March 11, 2011

Carson Helicopters, Inc. is writing to the National Transportation Safety Board regarding the final report and findings of the NTSB on the Sikorsky S61N helicopter crash near Weaverville, California on August 5, 2008. By this letter Carson is hereby filing a Letter of Petition to review the findings in this accident. Carson contends that, A) there is new and additional information regarding contaminants in the fuel system that should be given careful consideration, and B) the Board was not given complete and accurate performance information for review in reaching its findings regarding aircraft flight performance.

Comments on the Gen Hel Simulation for NTSB by Sikorsky Aircraft

Figure 9c.

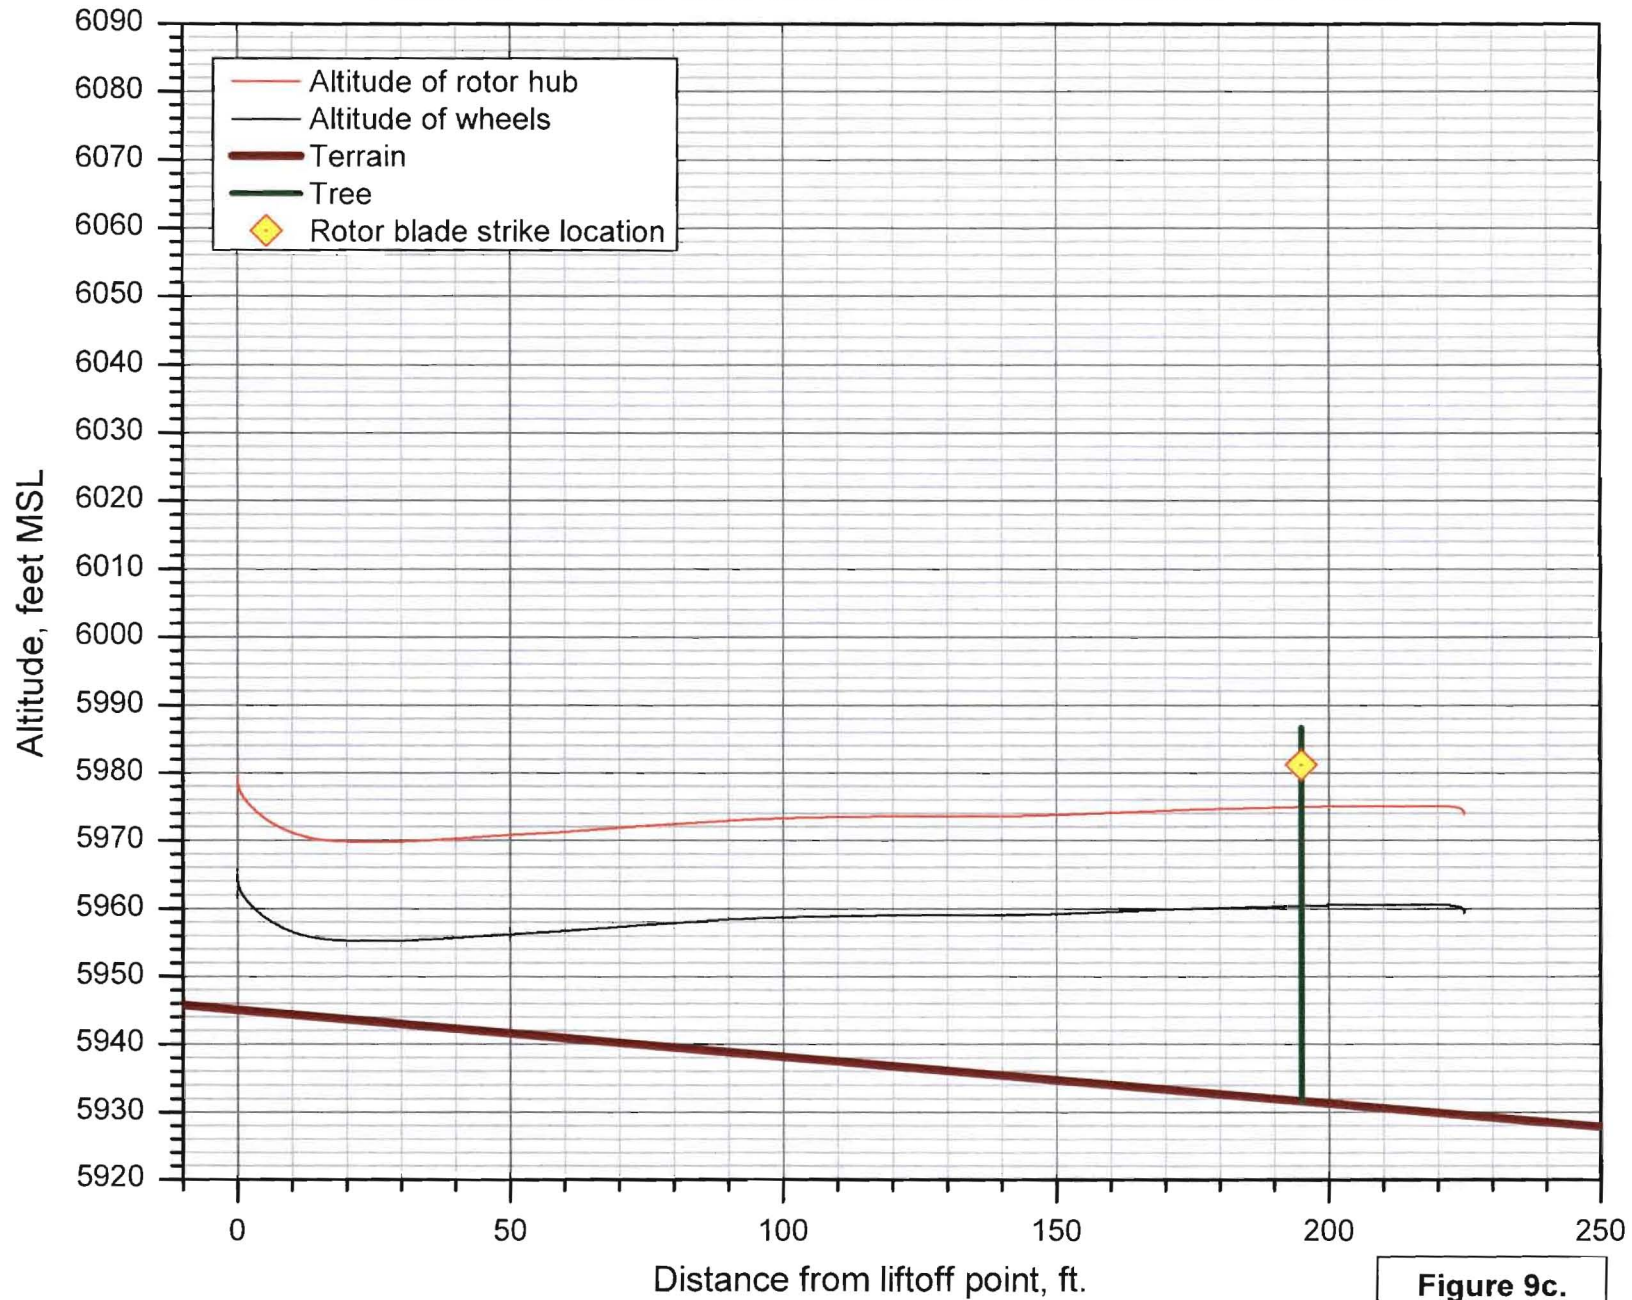
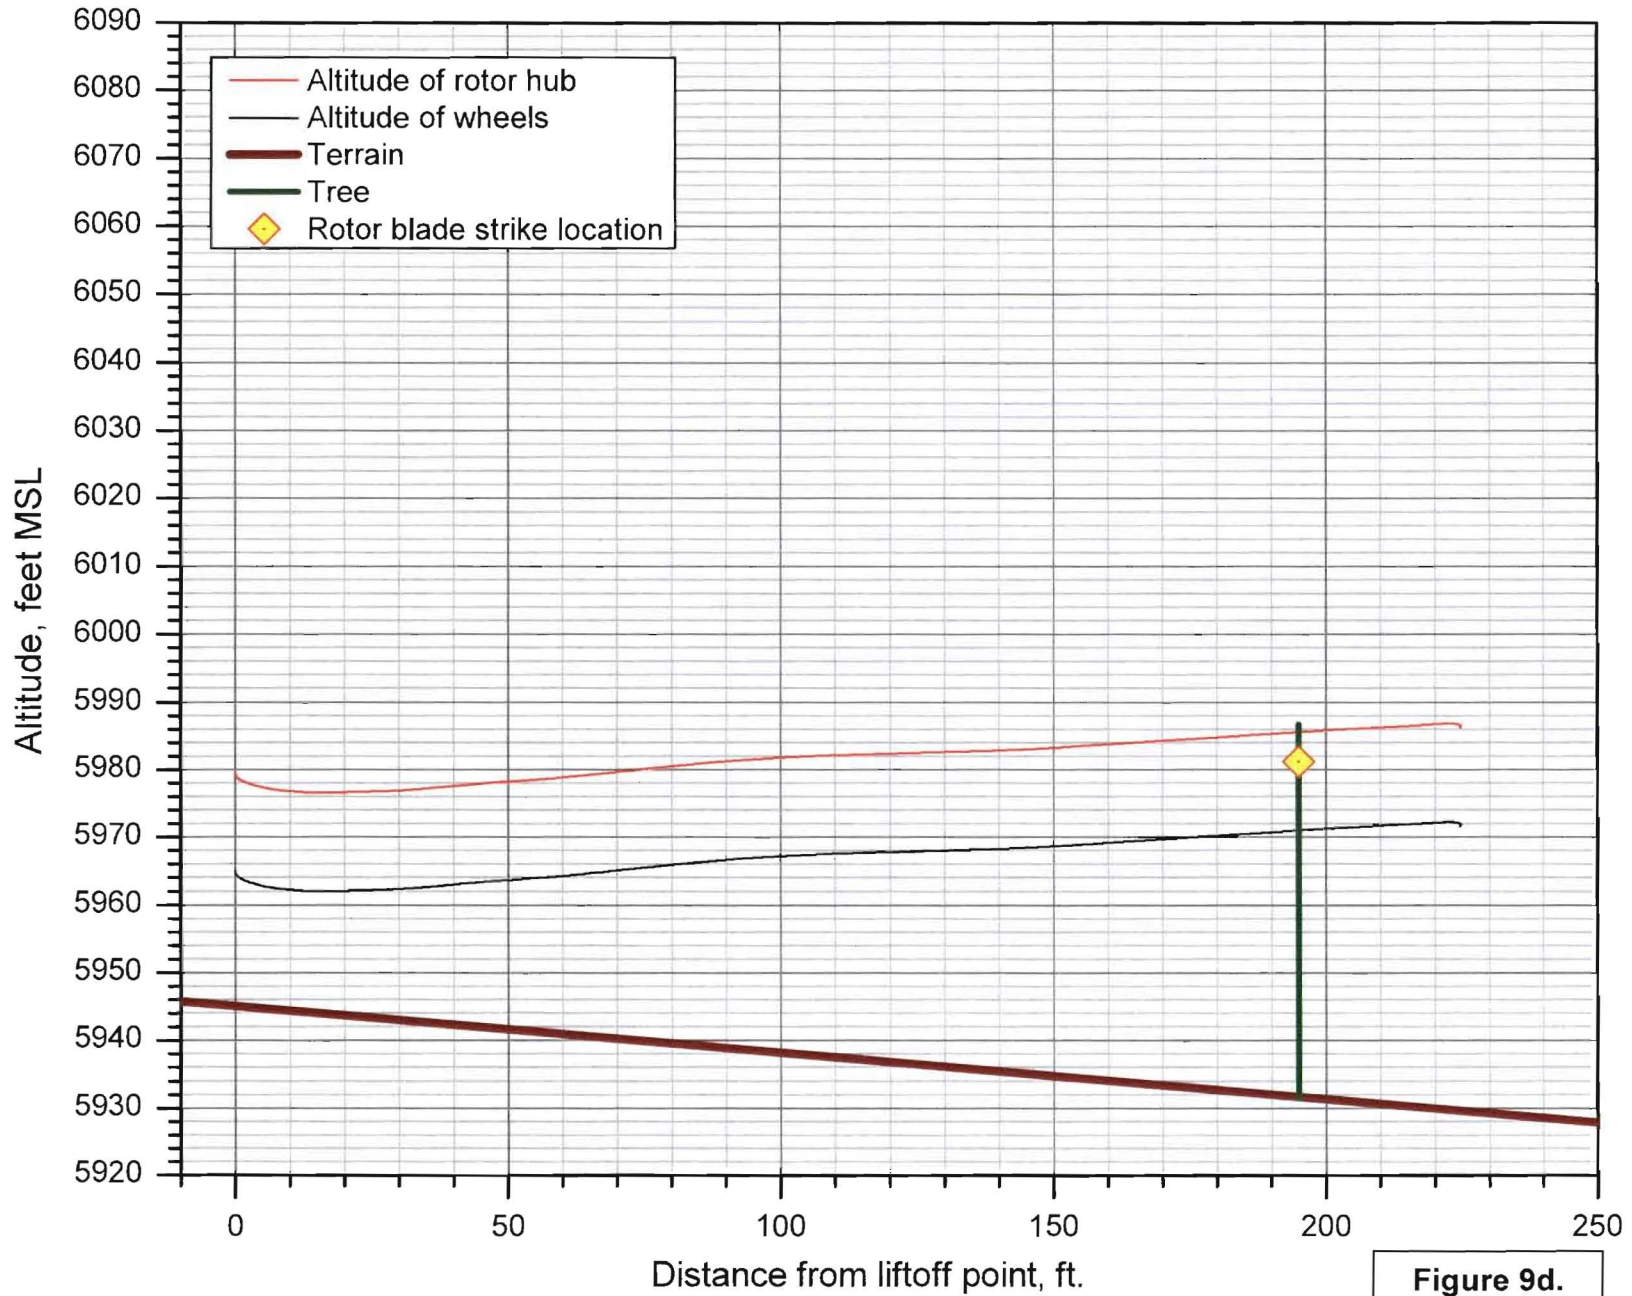
- d. This 2008 dataset with uncertified, one-off inferior CMRB blades is the only actual flight data that Sikorsky used in the GenHel simulation and which the NTSB investigators subsequently used in their final report (*see attached NTSB simulation results 9c, 9d*). It is no surprise that such a simulation would result in a flight path showing the aircraft without available performance to clear the trees, since by Sikorsky’s own admission this dataset does not remotely represent the actual superior performance of a commercial longbody S61N with regular FAA-approved CMRB blades.
